SOUTH YORKSHIRE MINING ADVISORY SERVICE

**BUILDING REGULATIONS 2000
APPROVED DOCUMENT A - STRUCTURE (2004 EDITION)
REQUIREMENT A2(b) - SUBSIDENCE**

Description: DETACHED DWELLING

Location: LAND ADJACENT TO 12 CONE LANE SILKSTONE COMMON.

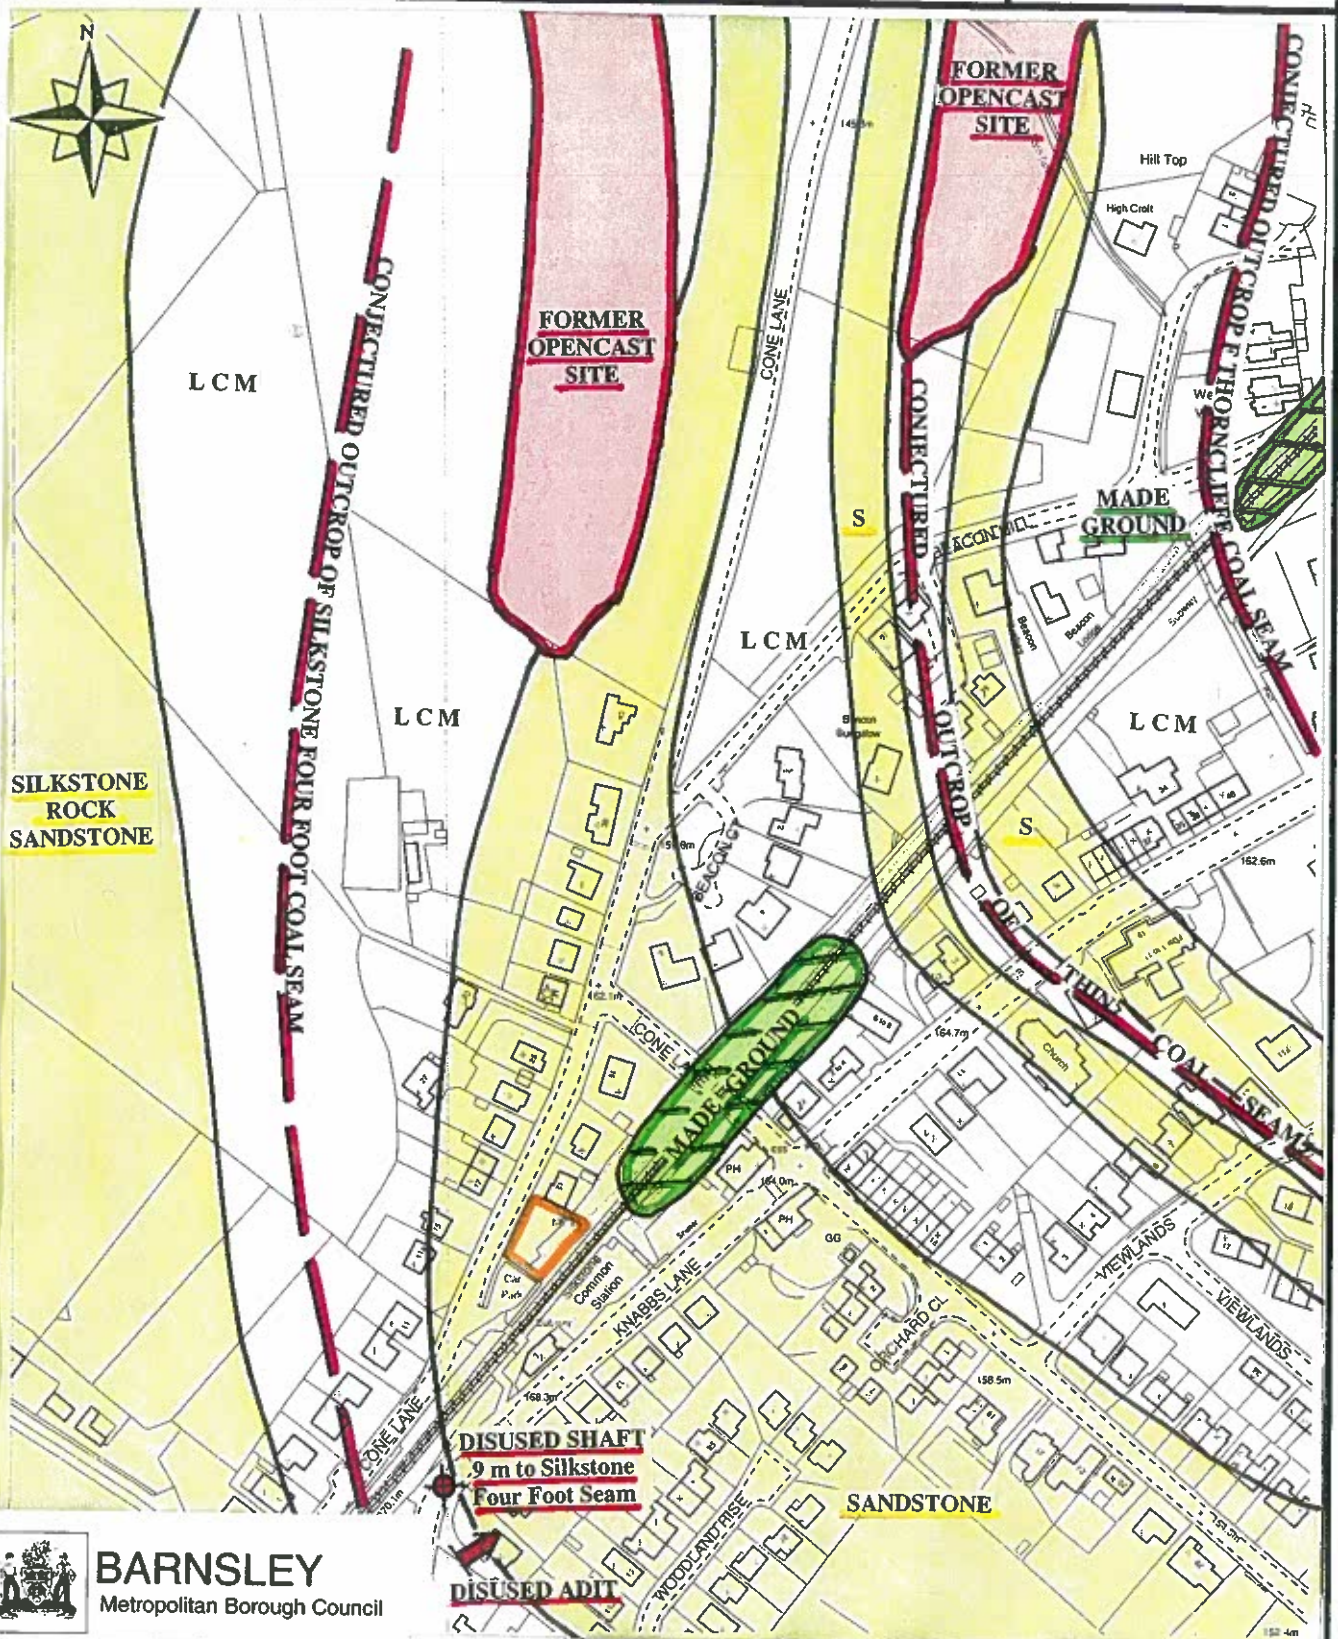
There is insufficient surface information on the site plan for a report to be completed.	A1
This site is fully/partially covered by previous report no.	A2
The conjectured surface position of geological faulting crosses the area as shown on the attached plan.	A3
Fissure problems may be encountered in the underlying sandstone bedrock.	A4
The conjectured outcrop of the coal seam marked on the attached plan may be exposed in the foundations.	A5
The coal seam shown on the plan may be under the proposed development at a shallow depth.	A6
Shallow mineworkings in the SILKSTONE FOUR FOOT coal seam marked on the attached plan may be present beneath the site.	A7 ✓
The mine shaft/adit marked on the attached plan is recorded within/adjacent to the site boundary.	A8
The area marked on the attached plan is shown to be made ground.	A9
The site will be affected by current/future mining.	A10

Where fault/fissure problems are encountered, the foundations should be suitably designed.	B1
Any coal exposed by building work should be blinded off to prevent spontaneous combustion.	B2
The necessity for an investigation should be balanced against size and type of proposed development/extension. Boreholes to a depth of m would be recommended in this instance. (Prior consultations with the Coal Authority would be required).	B3
A site investigation should be carried out to check the possible presence of shallow workings/broken ground. Boreholes to a depth of 16m would be recommended in this instance. (Prior consultations with the Coal Authority would be required).	B4 ✓
Ownership of coal mine shafts is vested with the Coal Authority who should be consulted prior to any investigation/measures being undertaken. In any event no building should be sited over the shaft or shaft cap or within an area bounded by a line drawn at 45 degrees back from where the shaft side intersects rockhead.	B5

The foundations may have to be suitably designed to minimise the effect of the current/future mineworkings.	B6
The nature and suitability of any made ground should be investigated.	B7
Precautions may be required should development be located over the highwall of the former opencast/quarry site due to the potential for differential settlement occurring.	B8
Although it is not a consideration of the A2(b) requirement all the usual safety precautions and monitoring procedures in respect of fugitive gases (associated with shallow coals, mine entries, made ground or landfill) should be employed during future excavations.	B9 ✓
